SPB Number: 2023.0302

EQUIPMENT UPDATES

STANDARD PLAN BULLETIN NOTICE
RaceTrac Engineering and Construction Division

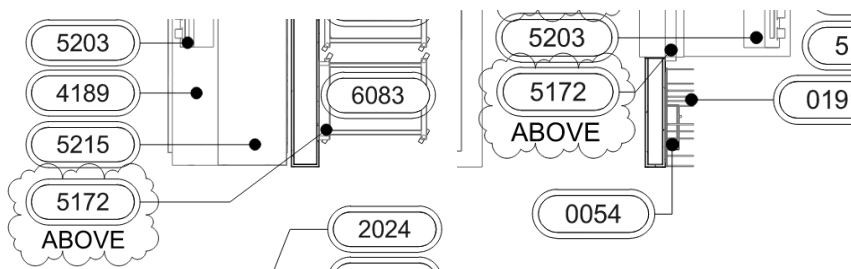
2. **FLY LIGHT:** Added equipment number and specification to Fly Light #5172.

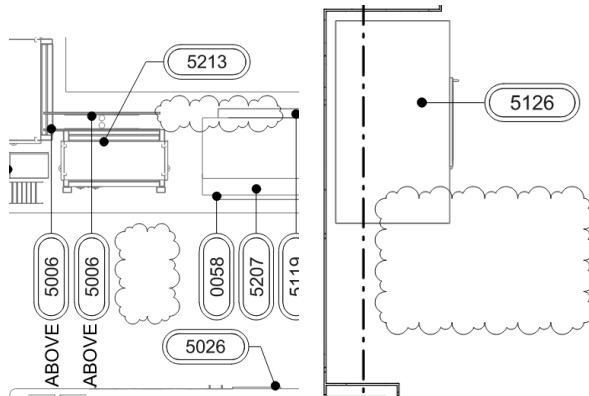
3. **MONITOR REMOVAL:** Removed (1) Monitor #5006 at the Food Area and (1) Monitor #5006 above Ice Merchandiser #5126.

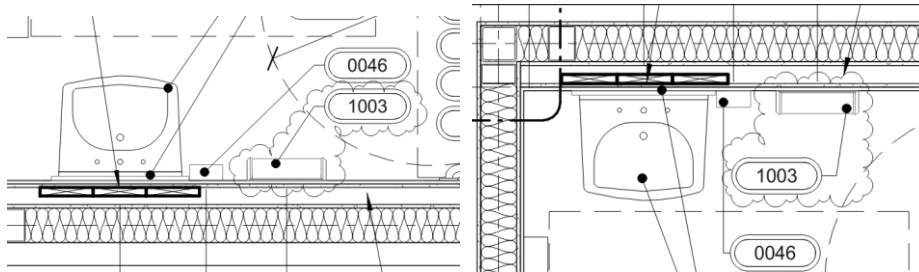
4. **HAND DRYER:** Replaced Towel Dispenser #0180 and Trash Can #0084 in the ADA stalls in both Men's and Women's restroom with Hand Dryer #1003.

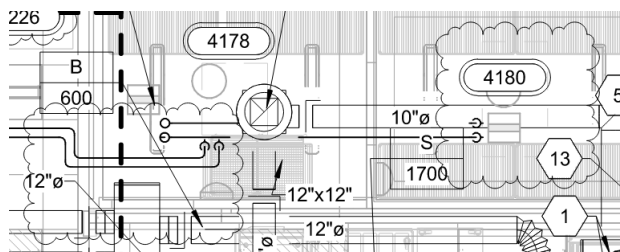
5. **EVAPORATOR UPDATE:** Rotated the Evaporators #4178 & #4180 at the Cooler and Freezer.

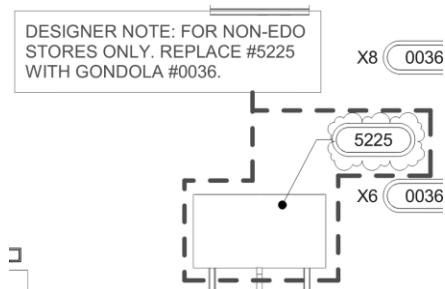
6. **ELECTRONIC CABINET:** Replaced Electronic Cabinet equipment #0108 with #5225.

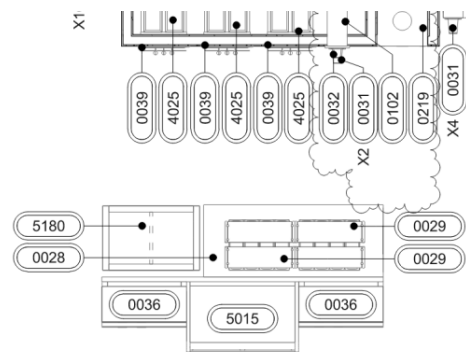
7. **YOGURT COLD PAN:** Removed the Yogurt Cold Pan #5035 and the hub drain at the Yogurt Topping Bar #0028.

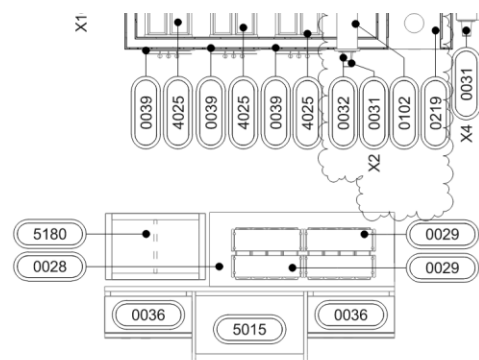
8. **YOGURT CABINET UPDATE:** Replaced Yogurt Cabinet #0033 with Yogurt Cone Dispenser #0102.
